Appl. No. 10/805,179  
Amdt. dated November 3, 2005  
Reply to Office Action of August 9, 2005

**Amendments to the Drawings**

**Remarks/Arguments**

FIG.5

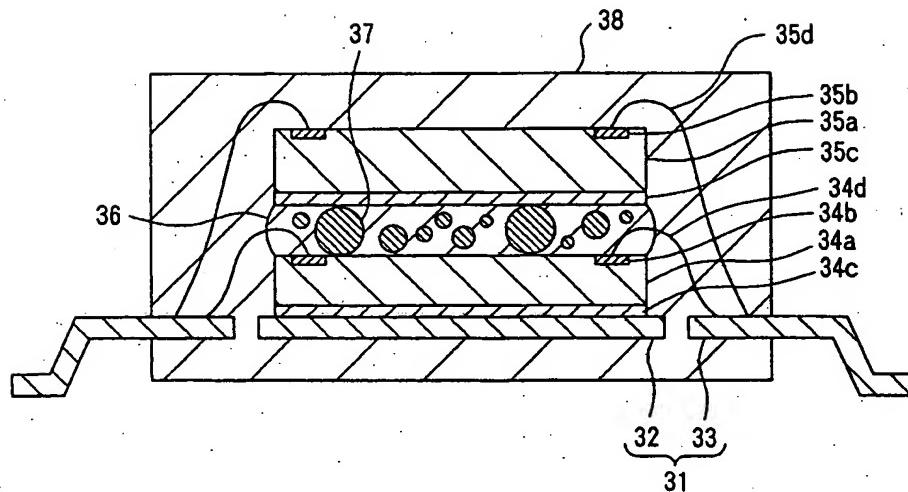
Figures 1-5 are objected to under 37 CFR 1.83(a) as not showing every feature of the invention specified in the claims. In particular, claim 11 recites that the *radius* of the globular particle is practically equal to a thickness of the insulating spacer whereas, Figures 1-5 show that the *diameter* of the globular particle is practically equal to a thickness of the insulating spacer.

In response, the term "radius" in claim 11 is changed to "diameter". Thus, the drawings now show all features of the claims and the objection should be withdrawn.

FIG.6

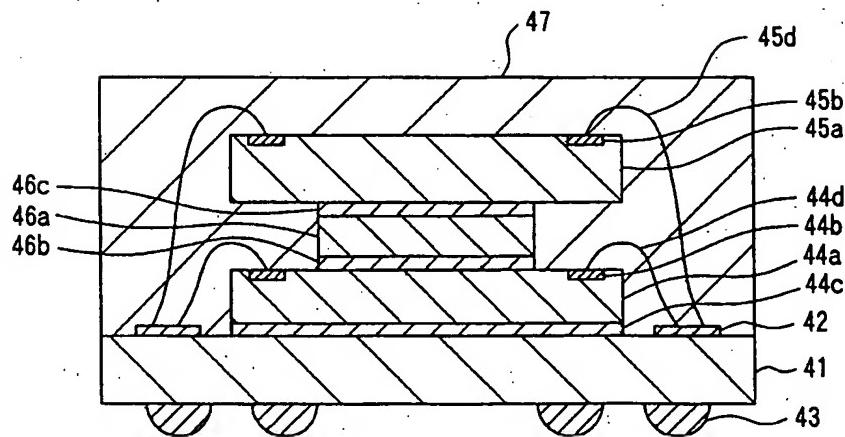
Figure 6 is objected to under MPEP 608.02(g) as lacking the legend --Prior Art--. In response, Figure 6 is amended to include the legend --Prior Art--. A replacement drawing sheet and an annotated sheet showing changes are attached.

The drawings are objected to under 37 CFR 1.84(p)(4) because reference characters 44a and 46a have both been used to designate the mirror chip. In response, applicant notes that in Figure 6, reference character 44a properly designates the lower semiconductor chip while reference character 46a designates the mirror chip. However, in one location in paragraph [0003] of the specification, mirror chip 46a is mistakenly referred to as semiconductor chip 44a. Paragraph [0003] is amended to correct this error, thereby overcoming the objections to the drawings.

The drawings are further objected to under 37 CFR 1.84(p)(4) because reference characters 44b has been used to designate both an electronic pad and a semiconductor chip. In response, applicant notes that in Figure 6, reference character 44b properly designates only the electronic pad. However, in one location in paragraph [0004] of the specification, semiconductor chip 45a is improperly designated as "44b". Paragraph [0004] is amended to correct this error, thereby overcoming the objections to the drawings.

The attached sheet of drawings includes changes to Figure 6. This sheet, which includes Figure 5, replaces the original sheet including Figures 5 and 6. In Figure 6, the legend --Prior Art-- has been added.

"PRIOR ART"
